February 24, 2023

RE: MSW Permit No. 2123 – Texas Disposal Systems Landfill TCEQ Tracking No. 28105718
Response to Clarifications and Request for Additional Information

We have reviewed your email and the 11 comments therein dated January 25, 2023. As requested, we have listed each of the comments with responses immediately following each comment where applicable:

Attachment 6-6.1. Subsurface Grades and Phase II/III Leachate Trenches and Permanent Sumps
	Texas Disposal Systems Landfill, Inc. Type I MSW Landfill, Creedmoor, Texas
Project No.: 2123 Date: Revised 2/24/2023

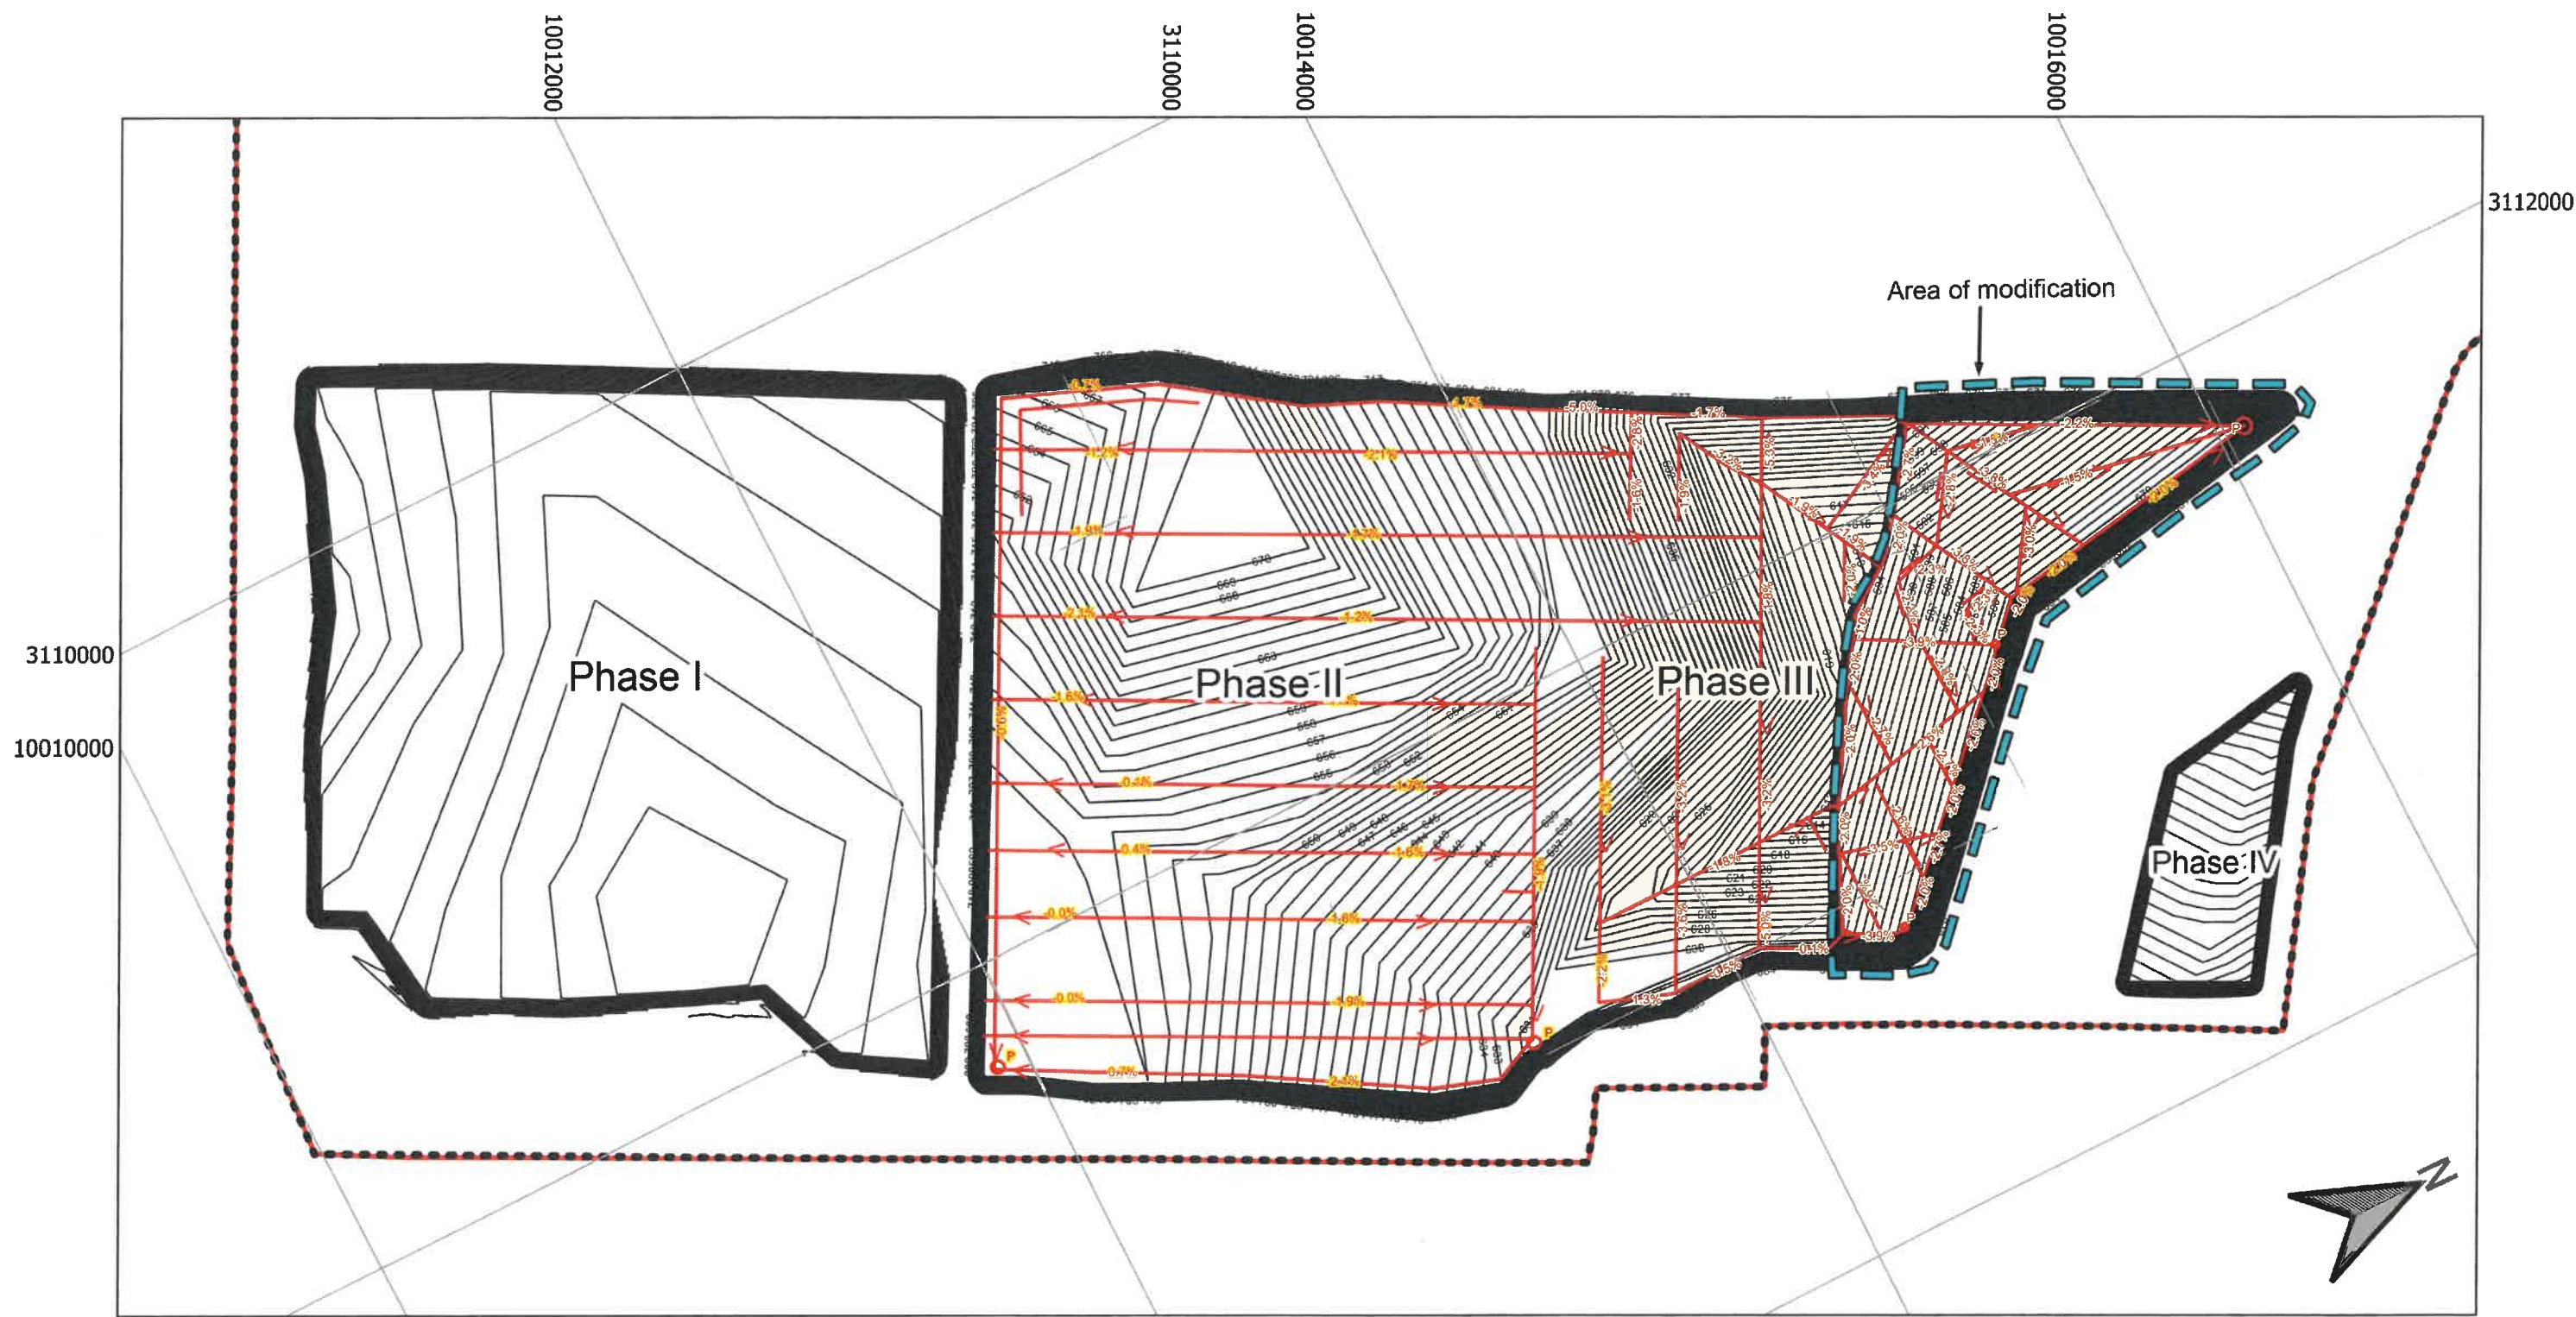
- **Remove the words “proposed” and “modified” from legends and title blocks to avoid future misunderstanding and uncertainty regarding status of the changes.**

Applicant Response: The words “proposed” and “modified” have been removed from legends and title blocks on Attachments 6-6.1., 9-6.1., and 9-6.1.a.

Texas Disposal Systems Landfill, Inc.	Attachment 9-6.1. Landfill Completion Plan Contours	
	Texas Disposal Systems Landfill, Inc. Type I MSW Landfill, Creedmoor, Texas	
	Project No.: 2123Mod Date: Revised 2/24/2023

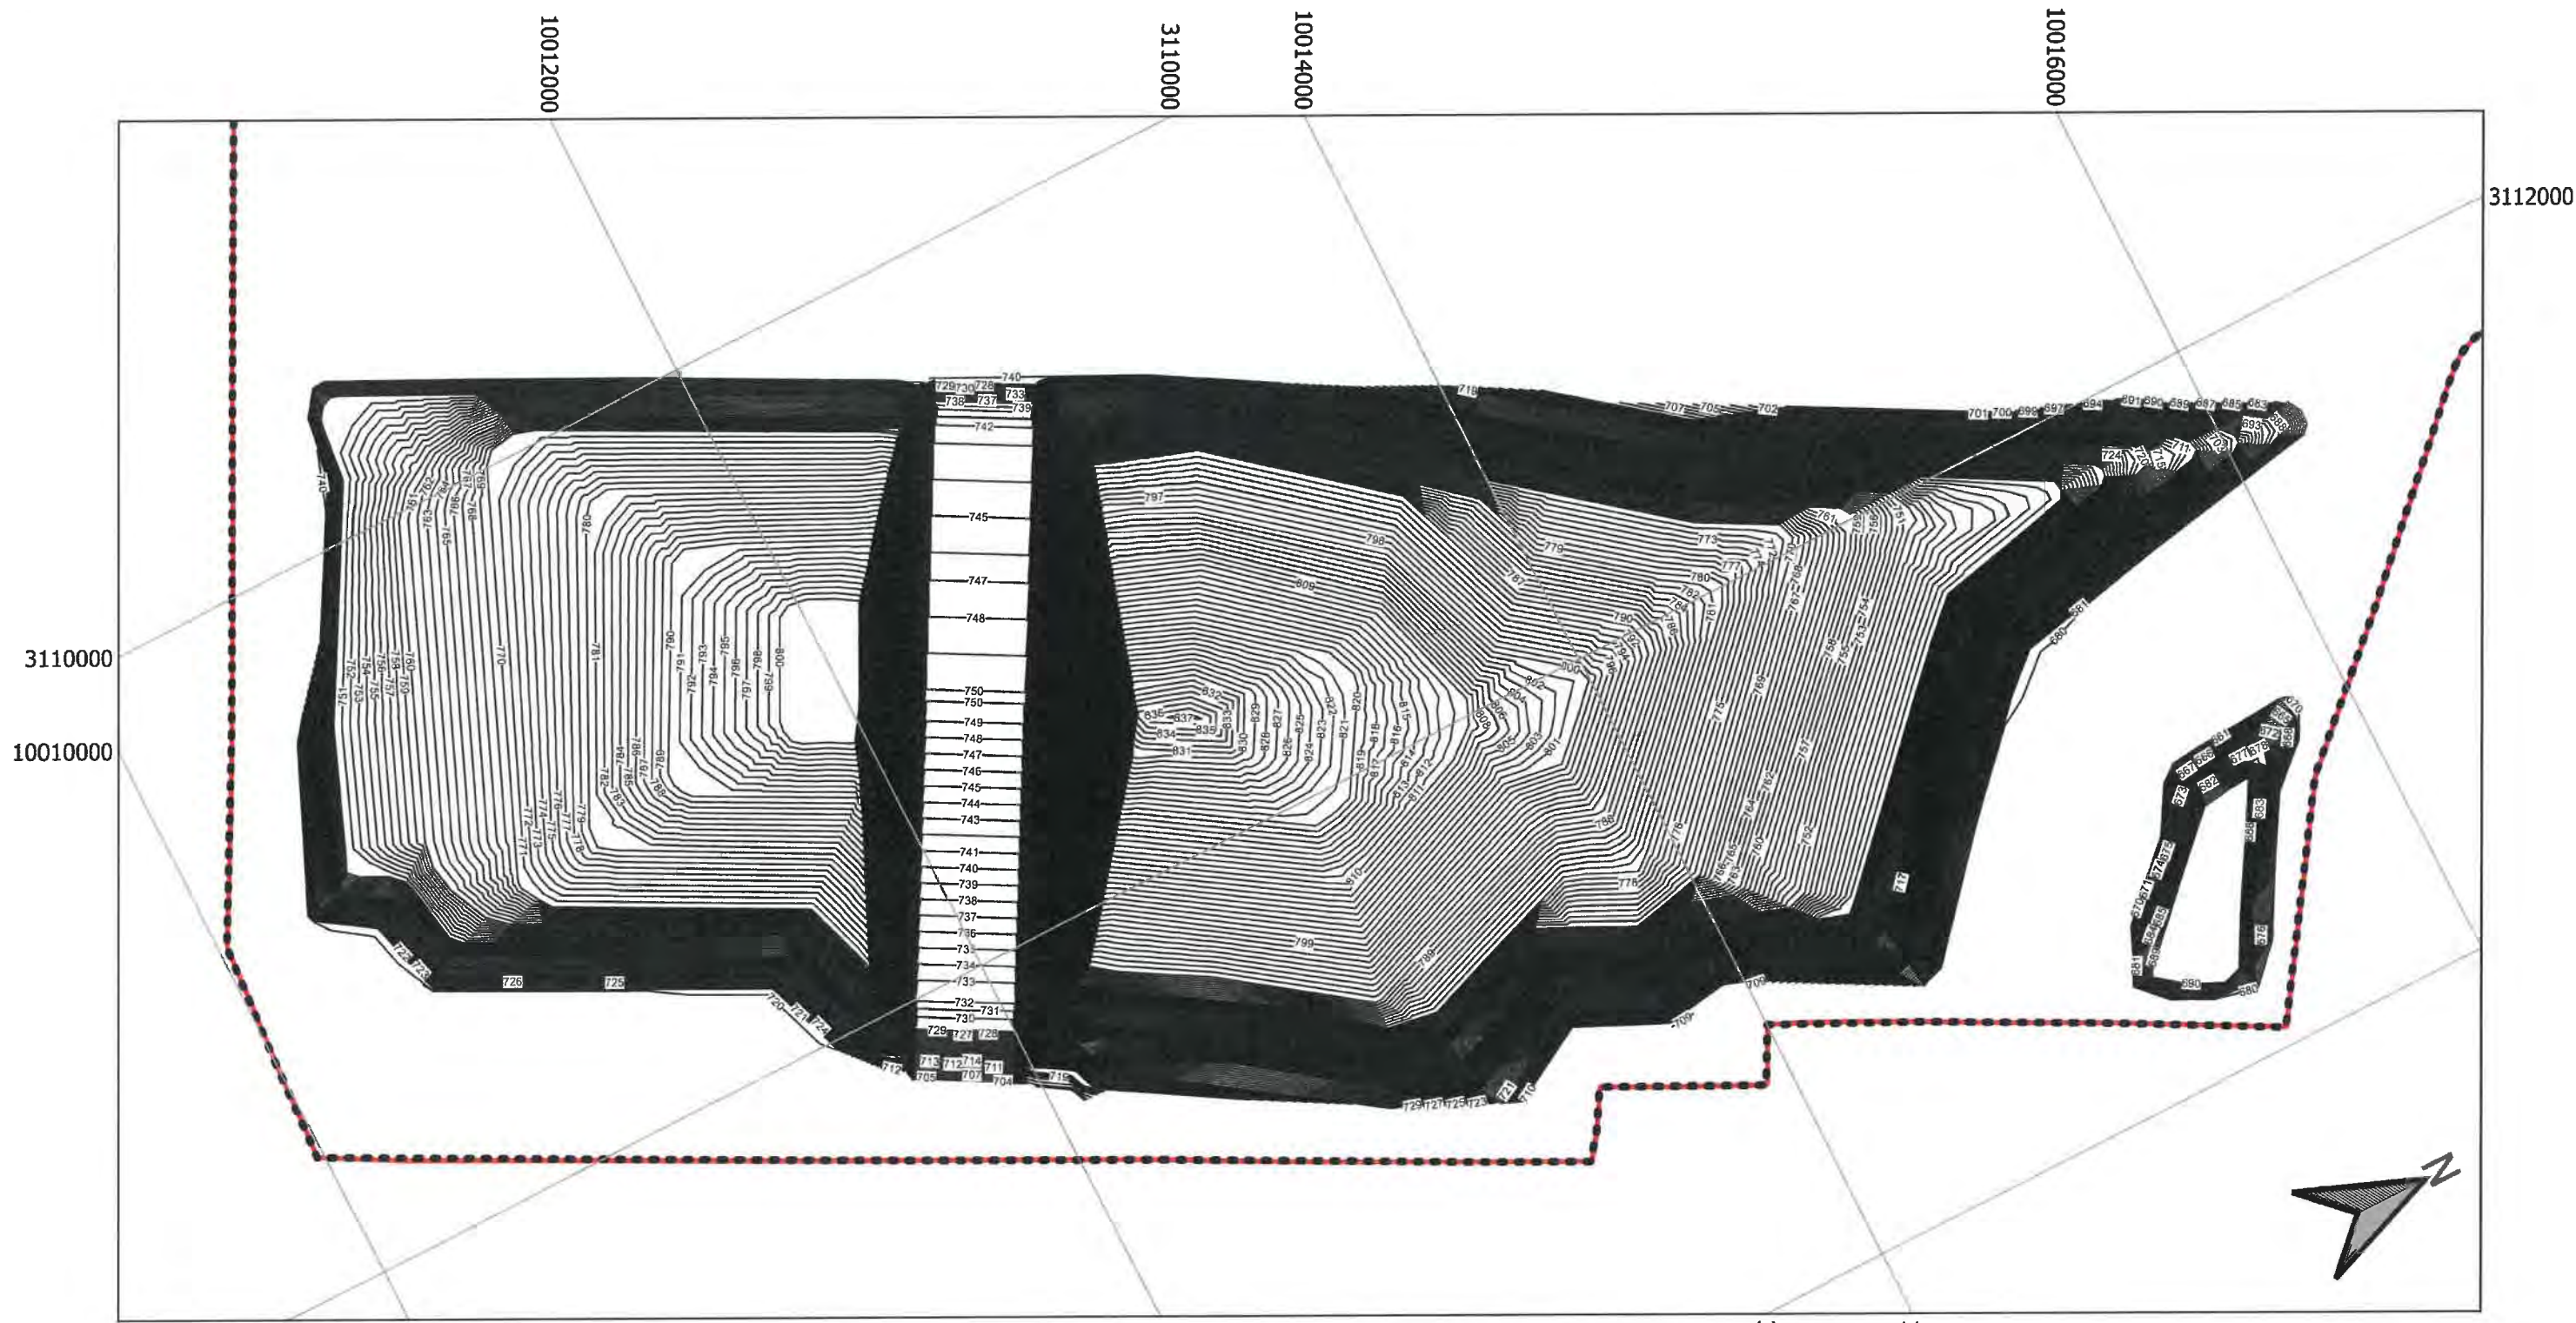
- **Delete or define the word “polyline” in the legends.**

Applicant Response: Labels have been added to Attachments 6-6.1., 9-6.1., and 9-6.1.a.

Applicant Response: The word “polyline” has been deleted from legends.

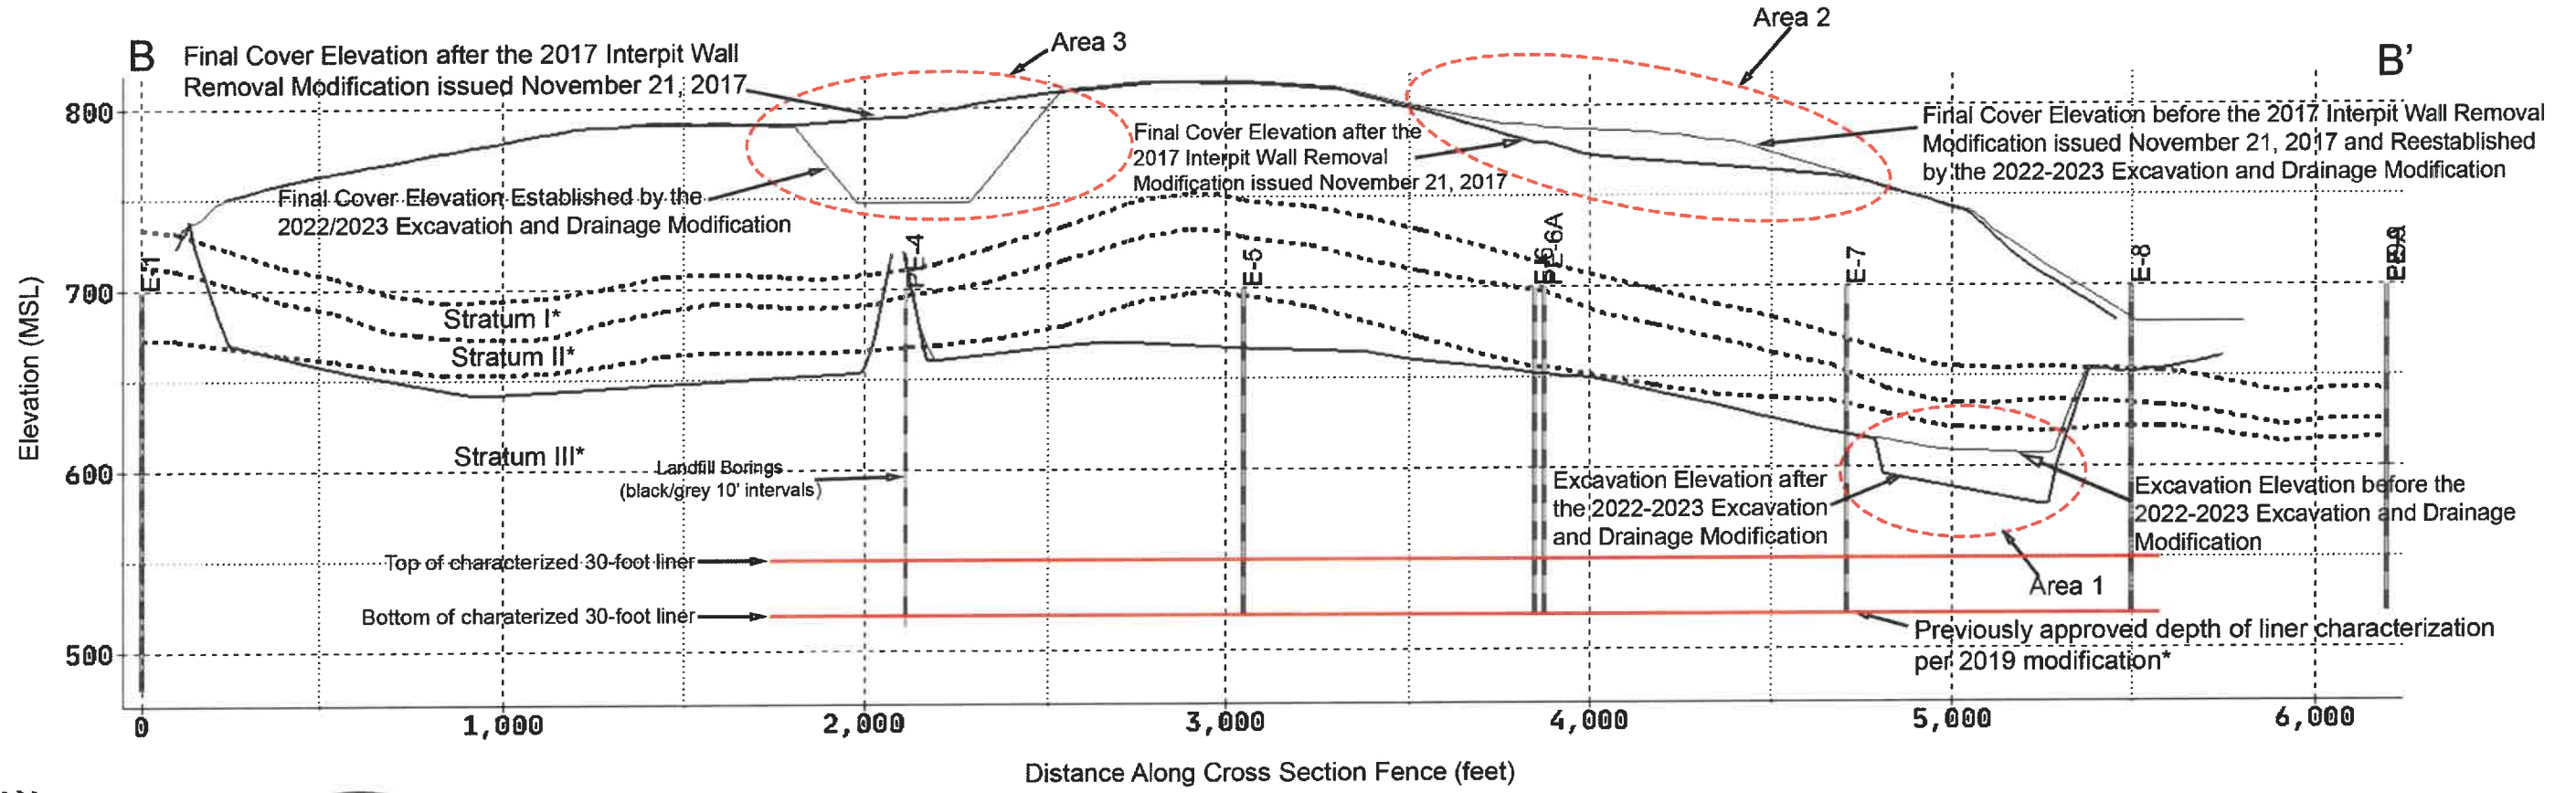
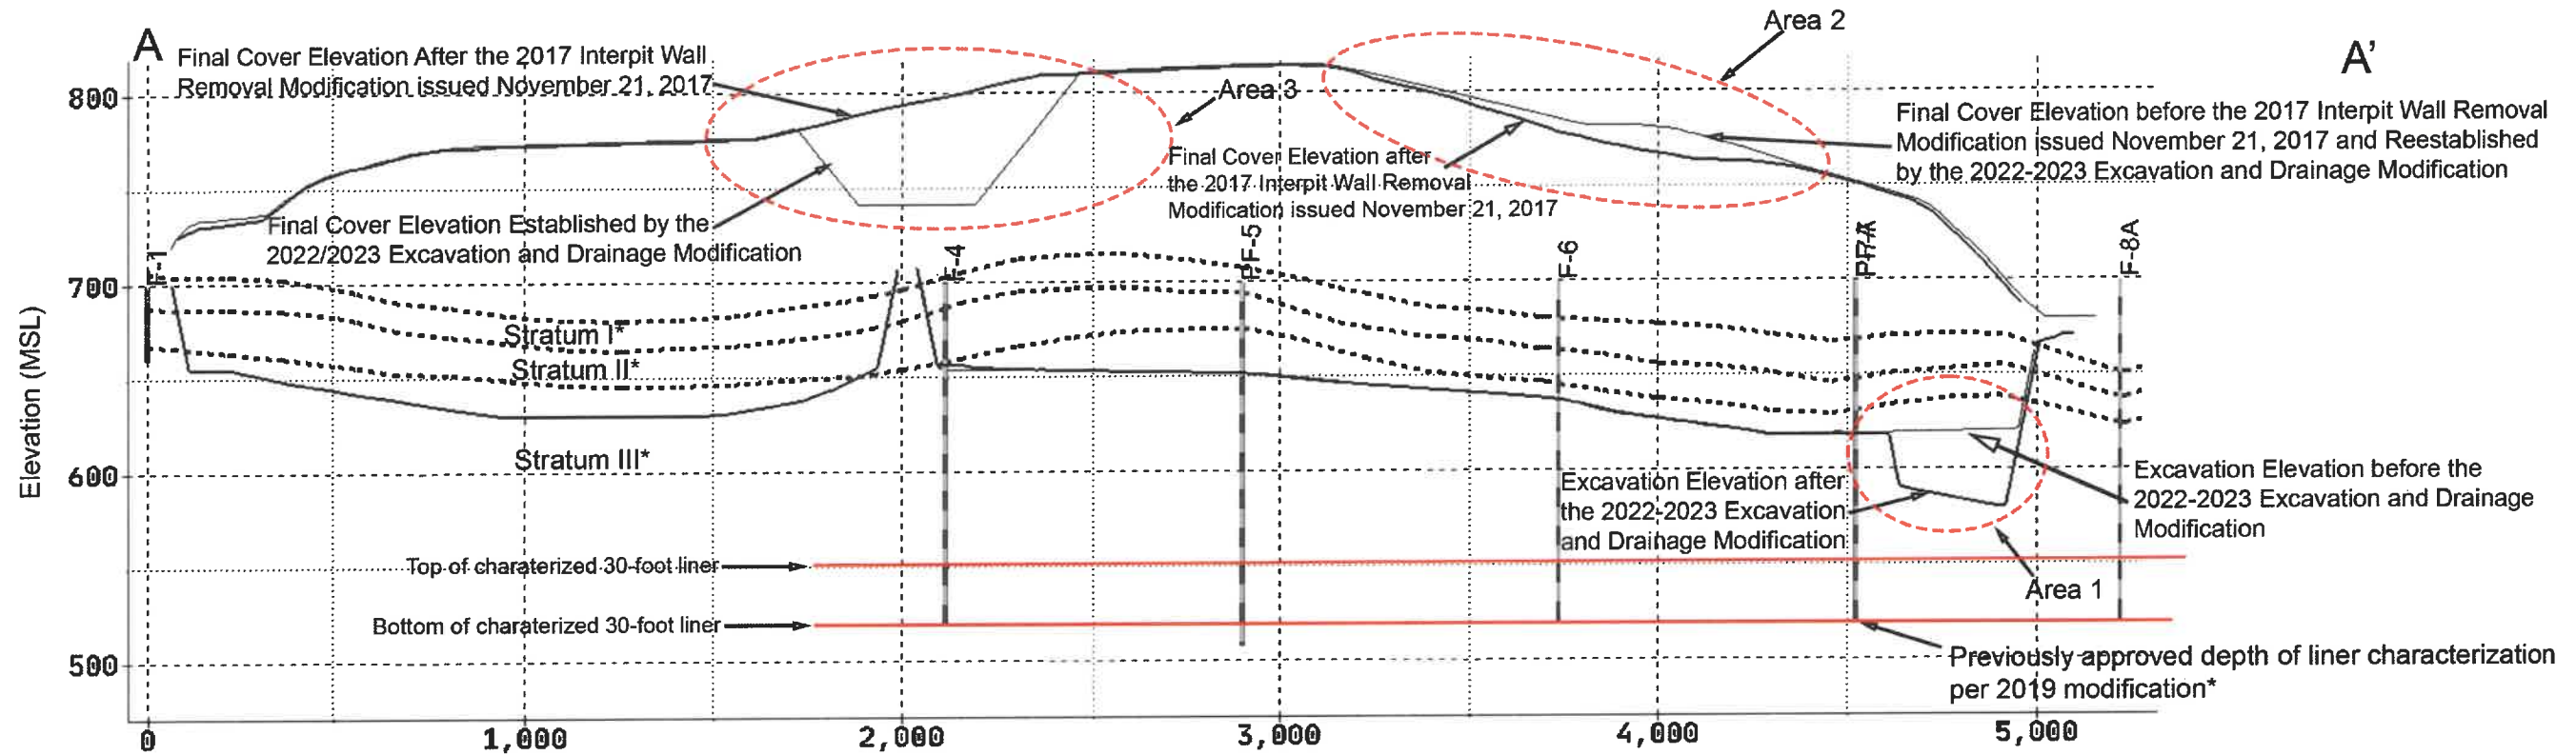
10. Revise drawing Attachment 9-6.1.b to address the following items on both cross sections:

- **Revise the “Original/Modified Design” label for Area 2 to indicate it refers to final cover elevation before the 2017 interpit wall removal modification issued November 21, 2017, and reestablished by 2022-2023 excavation and drainage modification.**

- **Revise the “Current Design” label for Areas 2 and 3 to indicate it refers to final cover elevation after the 2017 interpit wall removal modification issued November 21, 2017.**

- **Revise the “Modified Design” label for Area 3 to indicate it refers to final cover elevation established by 2022-2023 excavation and drainage modification.**

- ***In Area 1, add a label to the light-weight line to indicate it is the excavation elevation before the 2022-2023 excavation and drainage modification.***

- ***In Area 1, add a label to the heavy-weight line to indicate it is the excavation elevation after the 2022-2023 excavation and drainage modification.***

- ***The heavy-weight line in Area 1 appears to extend below the proposed EDE of 597 feet msl. Revise the cross sections to show proposed bottom elevation consistent with proposed EDE.***

Applicant Response: Attachment 9-6.1.b has been revised as requested.

Applicant Response: Attachment 9-6.1.b has been revised as requested.

Applicant Response: Attachment 9-6.1.b has been revised as requested.

Applicant Response: Attachment 9-6.1.b has been revised as requested.

Applicant Response: Attachment 9-6.1.b has been revised as requested.

Applicant Response: Attachment 9-6.1.b shows the EDE of 579 feet msl. Additional notes and text have been added to Attachment 9-6.1.b to provide clarity and the cross sections have been modified to only show Phases I and II/III.
